8533 RIVER DISTRICT CROSSING - "Parcel 15"
(COMPLETE APPLICATION)
DE418328 - ZONE CD-1

DEVELOPMENT PERMIT STAFF COMMITTEE MEMBERS

DEVELOPMENT PERMIT STAFF COMMITTEE RECOMMENDATION: APPROVE

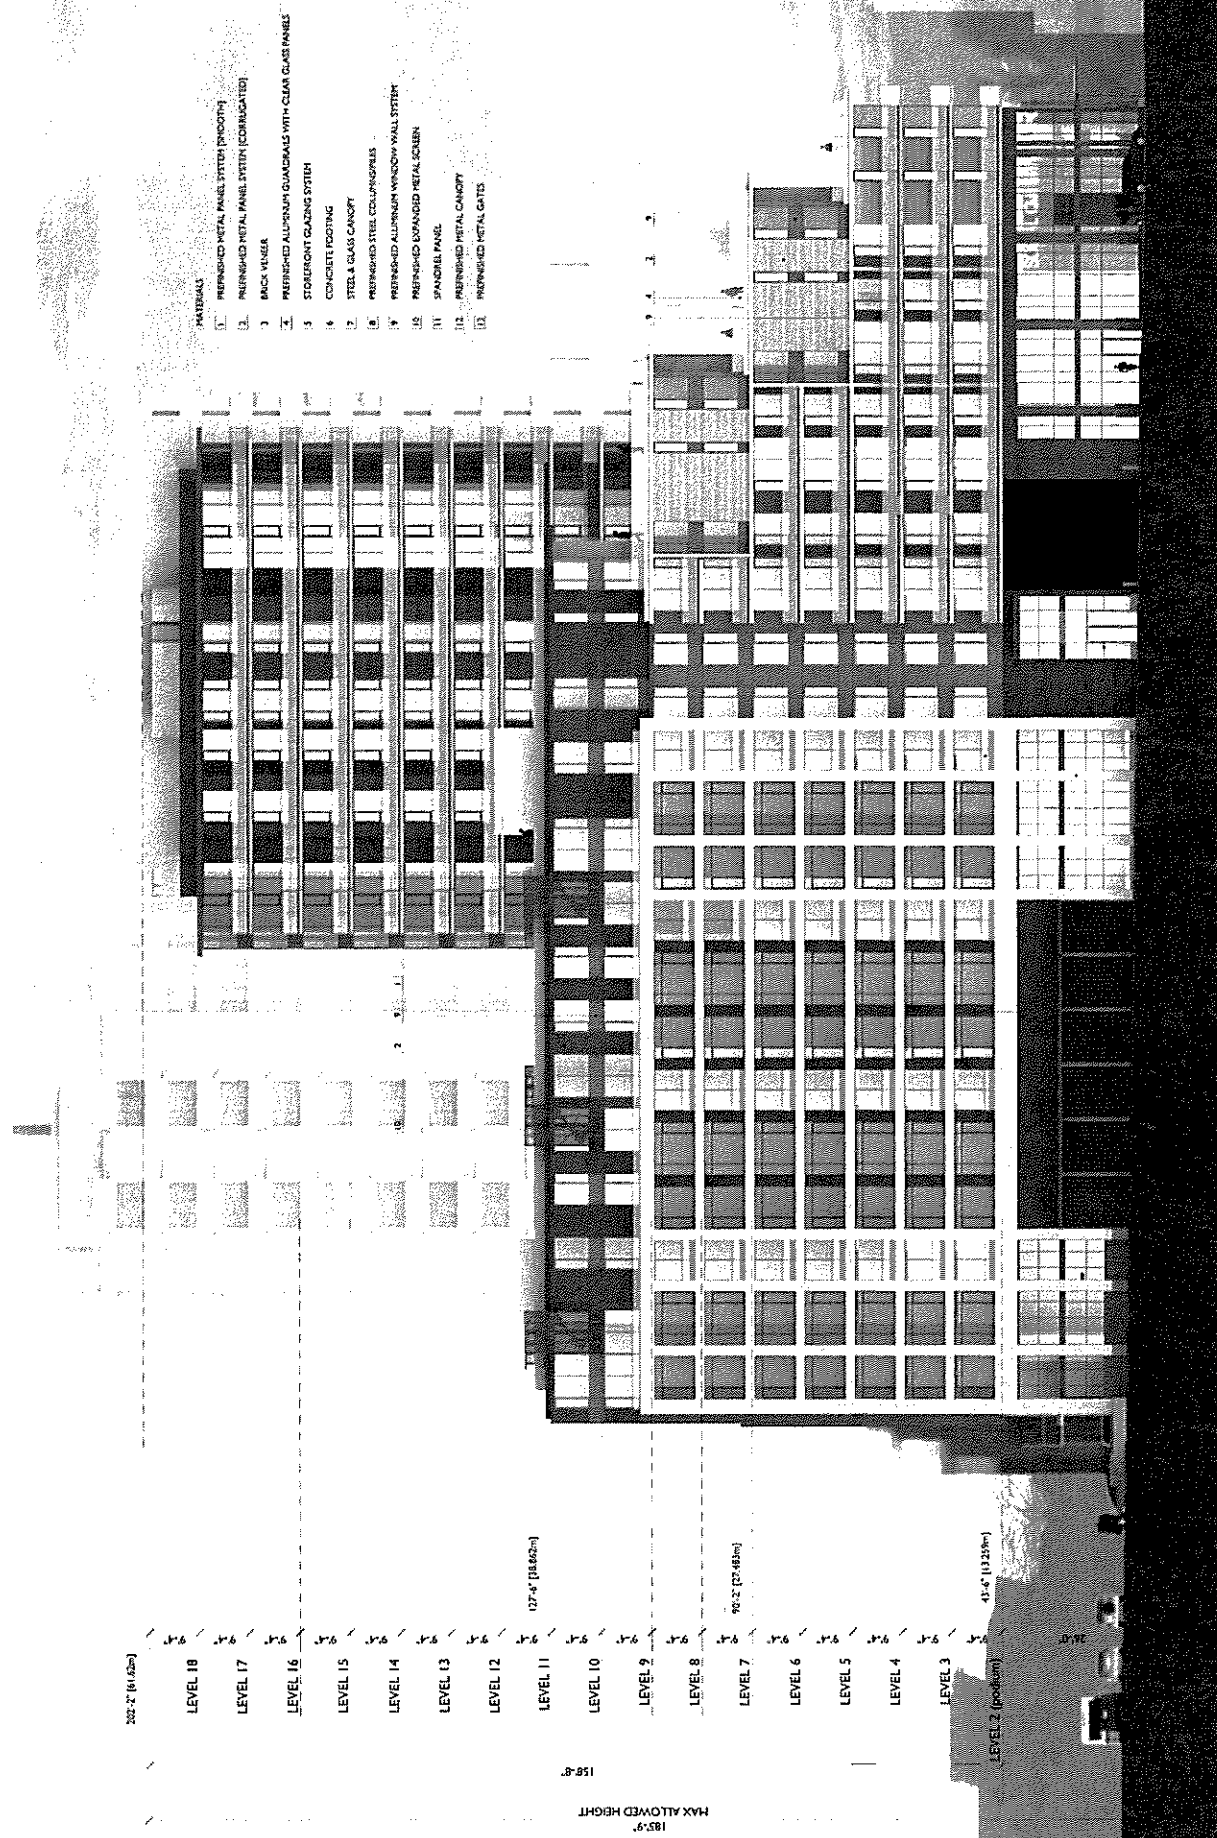
- f. provision of directional signage at the bottom of the ramp to direct drivers to the commercial, residential, carshare and visitor parking as there is no circulation on the P1 level;
- g. modification the access to the bike room at gridline L/10 on drawing A-2.03 as parked vehicles would restrict access;

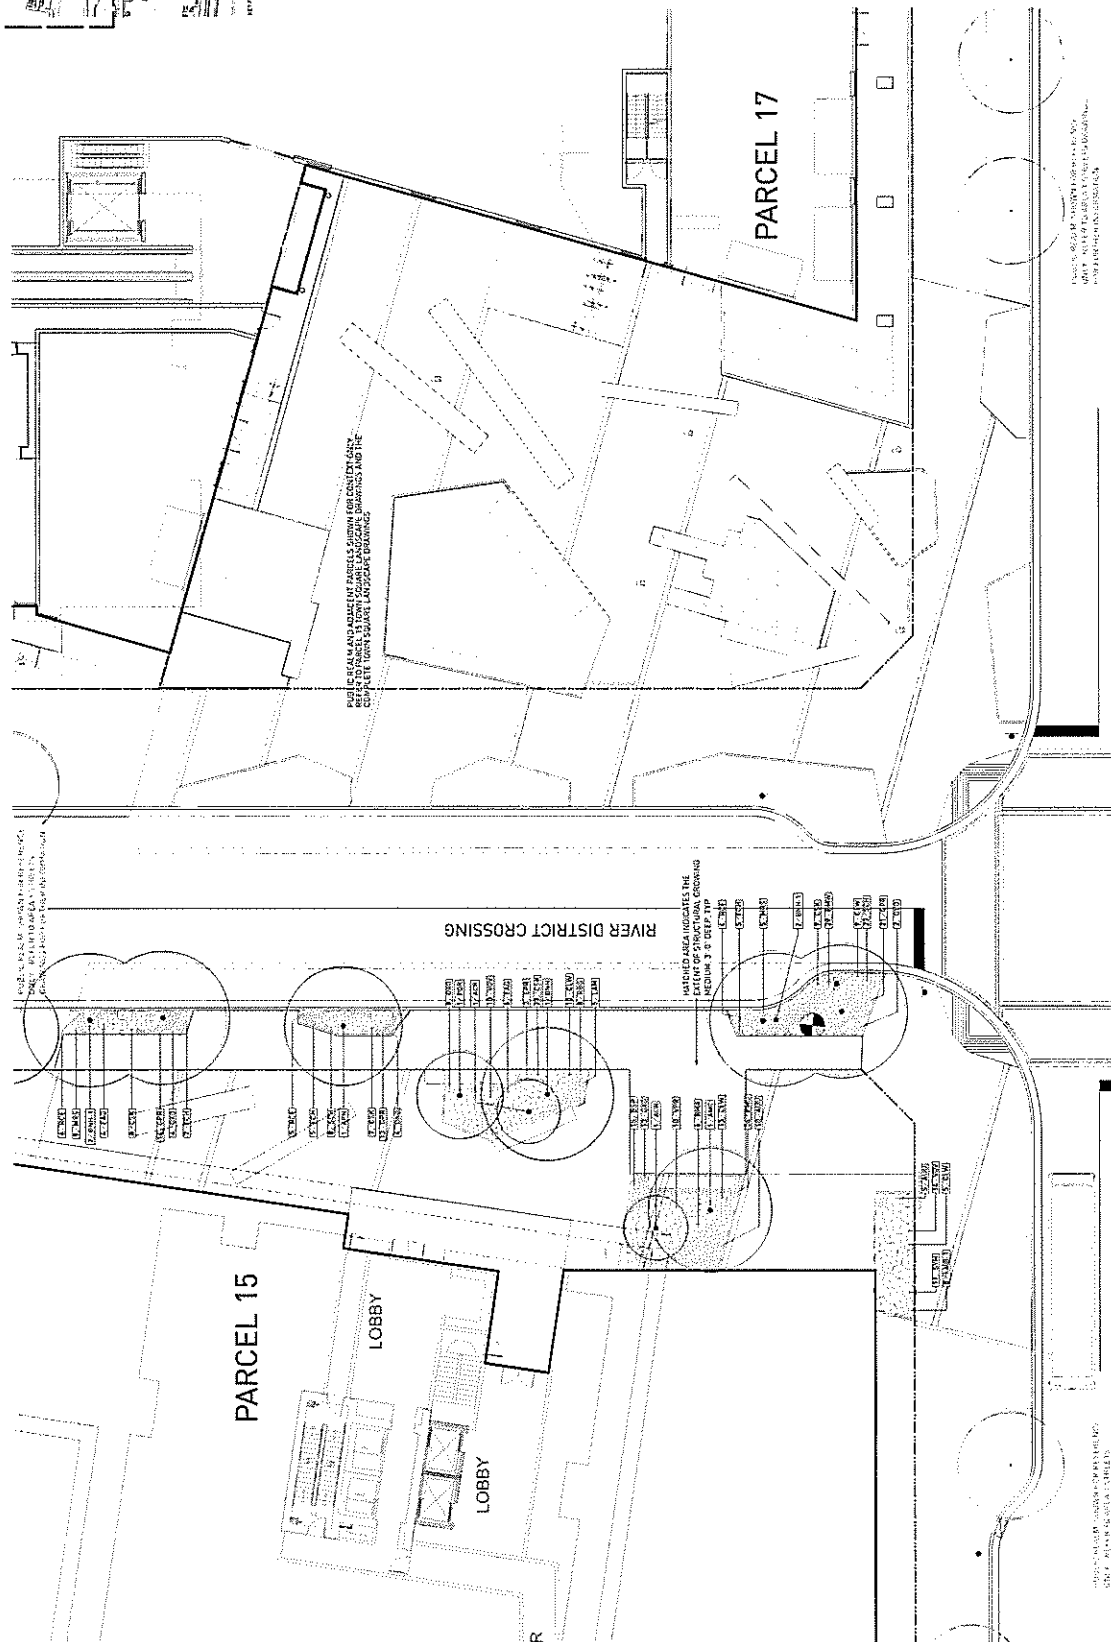
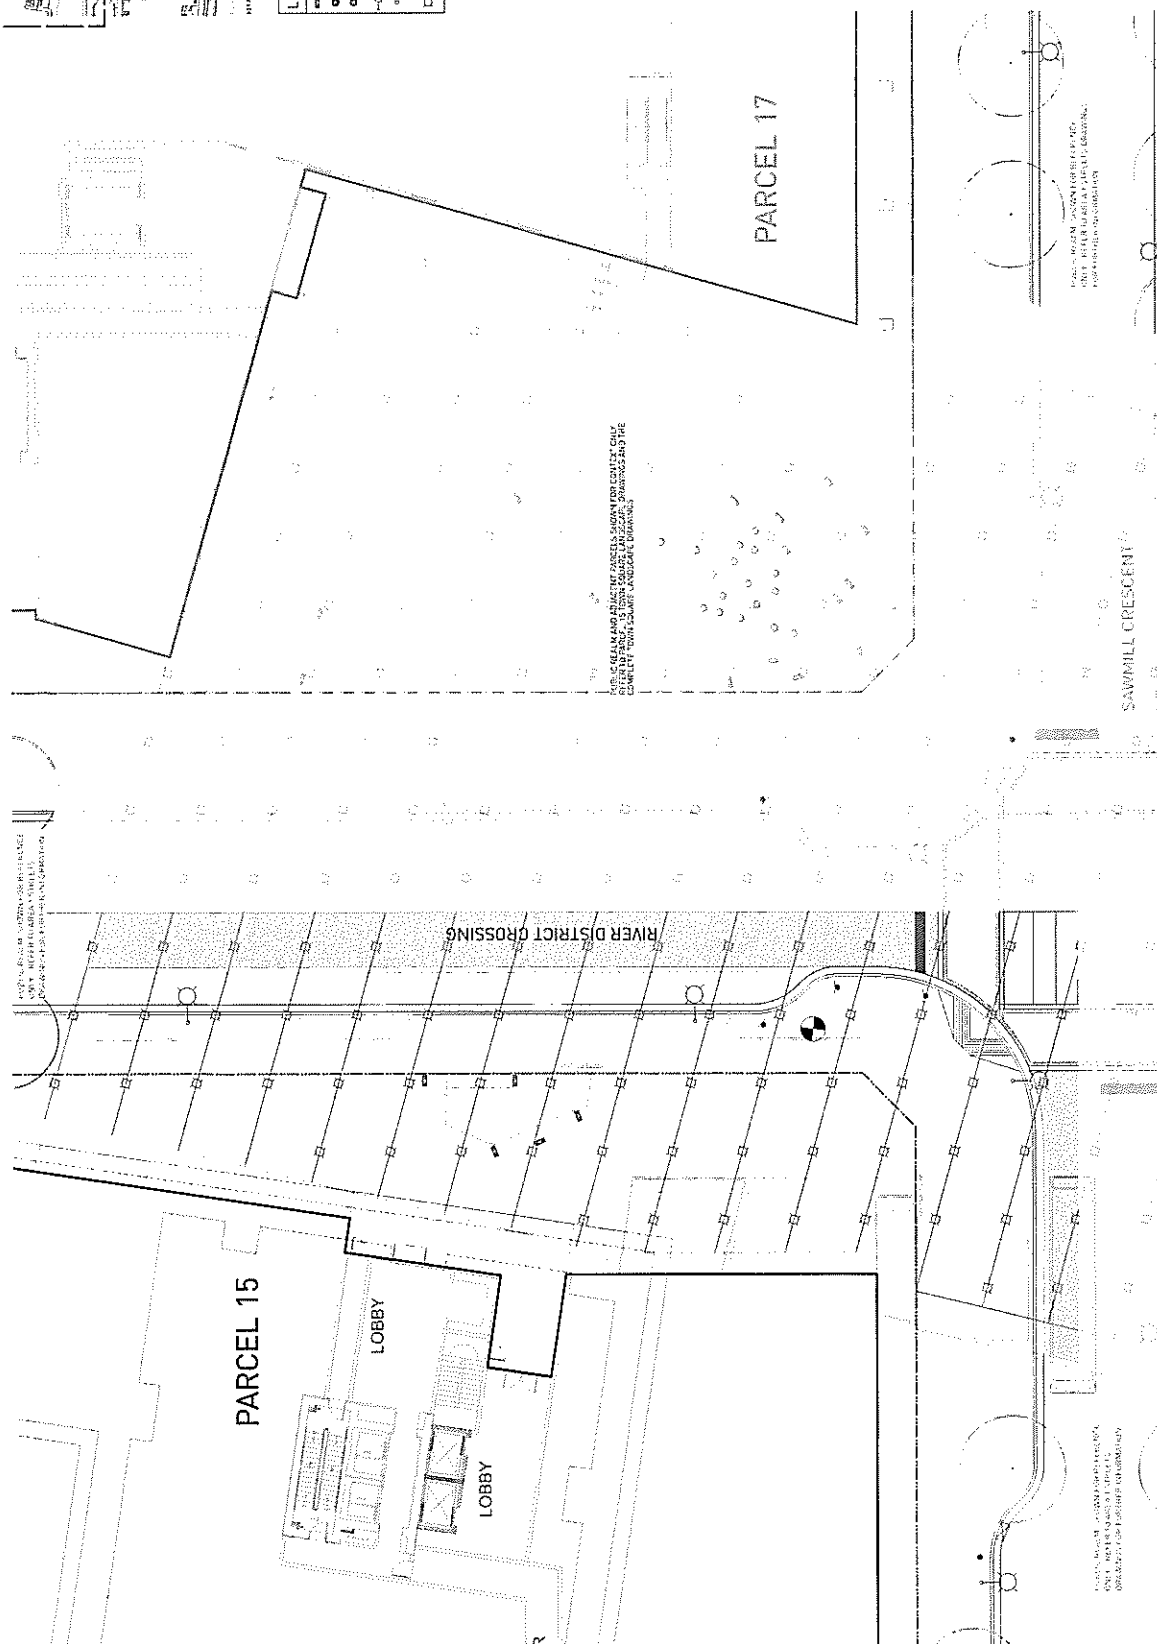
A.2.24 relocation of the trash receptacle shown on drawing LDP1.01 onto private property;
